2 Site - Callout 1
1 1/2" = 1'-0"

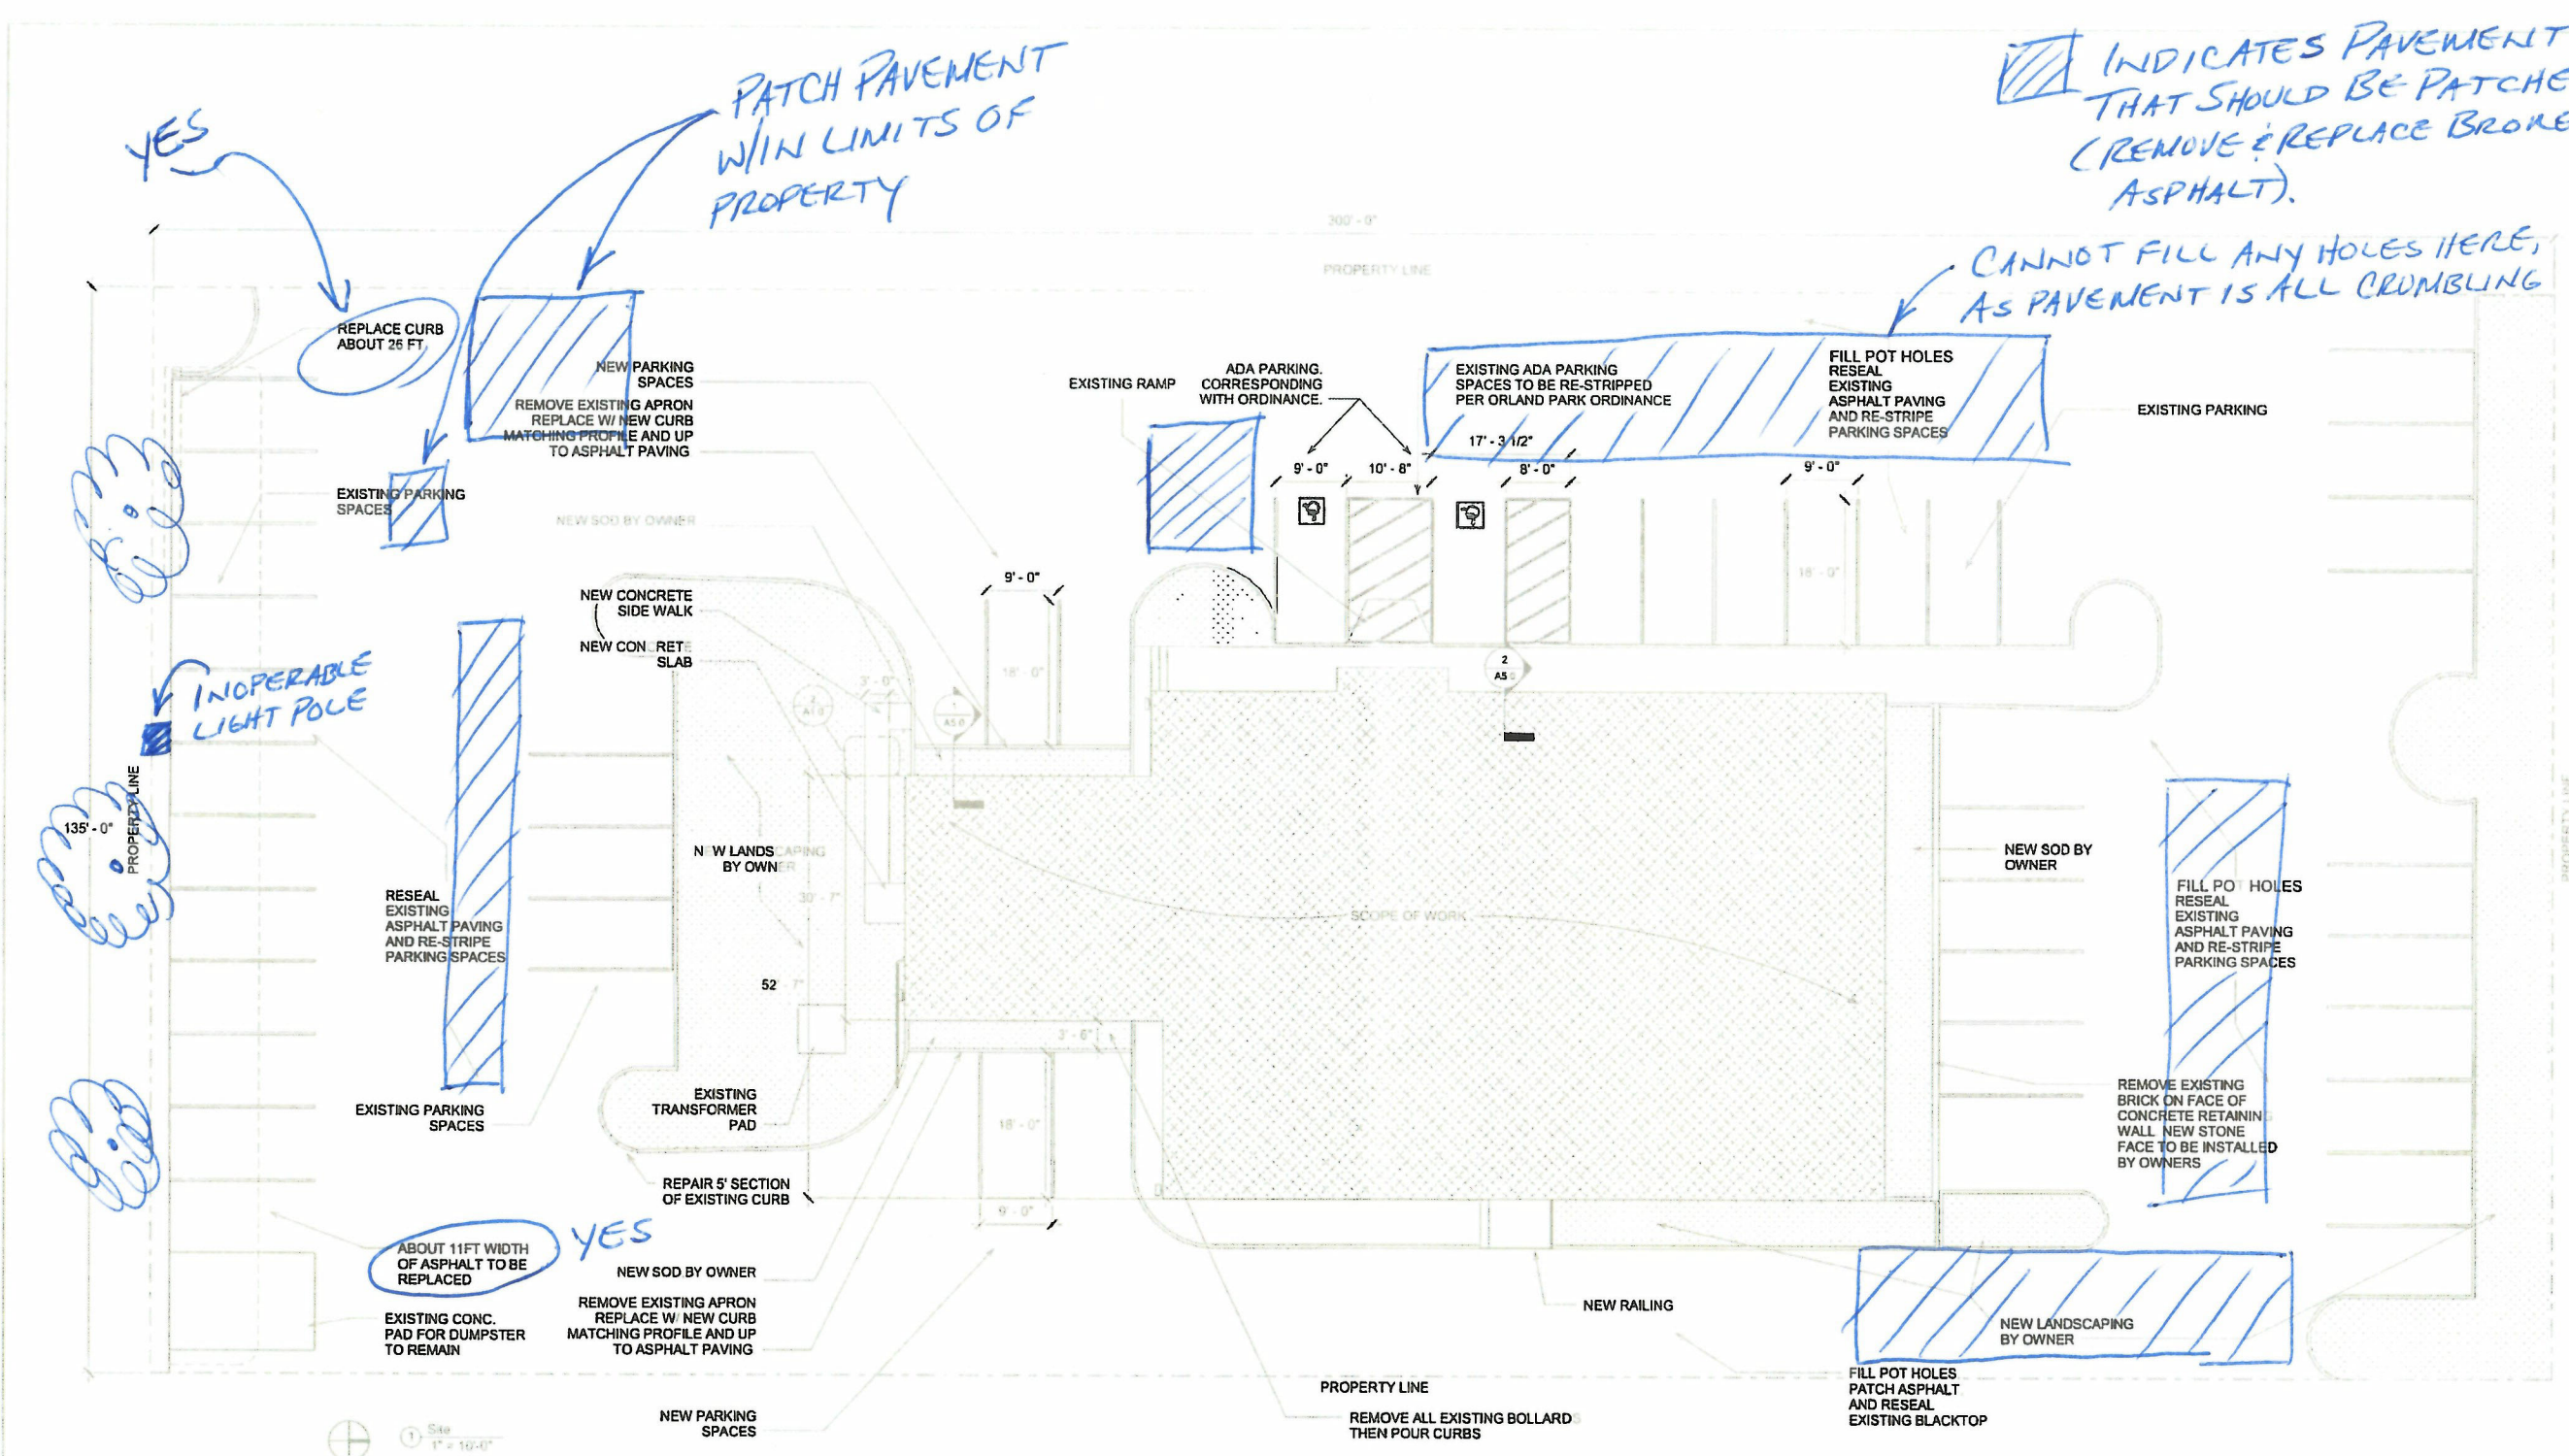
- NOTICED SEVERAL PARKING BLOCKS/WHEEL STOPS AROUND PARKING LOT. SINCE THE LOT IS CURBED, IT WOULD SEEM THESE BLOCKS SHOULD BE REMOVED.
- 3 SICK TREES @ SOUTH PROPERTY SHOULD BE REMOVED.
- REMOVE INOPERABLE LIGHT POLE & BASE FOUNDATION.
